Subject: Metropolitan Mine Mod 4 Longwalls 317 and 318 – Response to Submissions (MP 08_0149 MOD 4)

CPHR Review of the Response to Submissions

Mod 4 Metropolitan Coal Mine – Longwalls 317-318 – CPHR comments on Response to Submissions (RTS)

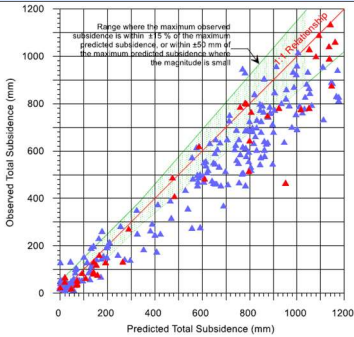
Issue no.	Reference		
CPHR Review – Modification Report			CPHR Review- RTS
			Clarify if the Giant Dragonfly measurement parameter of “relative abundance” is necessary, or whether “abundance” is more appropriate, and update if required. <i>CPHR comment</i> Response adequate Recommendation 17.9 Undertake further assessment to determine if the Ventilation Shaft construction will impact S92. <i>CPHR comment</i> Matter dealt with under Issue 1 and 19. Recommendation 17.10 Should approval be granted, the Consent Authority clarify through conditions of consent that changes to listing status of threatened entities is to be considered when assessing Performance Measures and offsetting. <i>CPHR comment</i> Matter for Consent Authority
CPHR Review – additional matters			
18	Modification Report Figure ES-2	The Modification includes first workings for a new mine to the west of the current mine lease without any environmental assessment. It also identifies that the northern end of the proposed longwall (LW) 318 extends beyond the Metropolitan mine approved extraction area and into an Exploration Lease area. The proposed modification must be “substantially the same development” as that approved as required under s4.55 of the EP&A Act. This includes both “quantitative” changes, as in increases or	Recommendation 18.1 Provide information that determines the first workings/gate roads enabling a whole new mine area to the west is “substantially the same development” as that approved and does not warrant a separate new approval and associated assessments. <i>CPHR Comment</i>
